United States Patent and Trademark Office

APPLICATION NO.	FILING DATE	FIRST NAMED INVENTOR	ATTORNEY DOCKET NO.	CONFIRMATION NO.
10/815,293	04/01/2004	Matthew Donofrio	5308-390	8325
20792	7590 11/22/2006		EXAMINER .	
MYERS BIGEL SIBLEY & SAJOVEC PO BOX 37428			CHAMBLISS, ALONZO	
RALEIGH,			ART UNIT	PAPER NUMBER
ia ibbioii,			2814

DETAILED ACTION

Figure 10

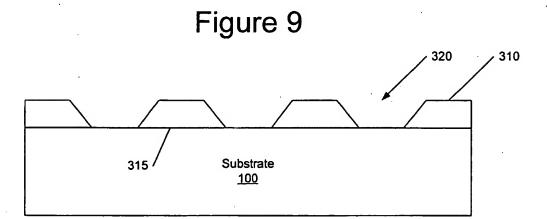
2. The drawings are objected to under 37 CFR 1.83(a). The drawings must show every feature of the invention specified in the claims. Therefore, a micro mask between the mask layer and the substrate that has a thickness must be shown or the feature(s) canceled from the claim(s). No new matter should be entered.

Not approved.
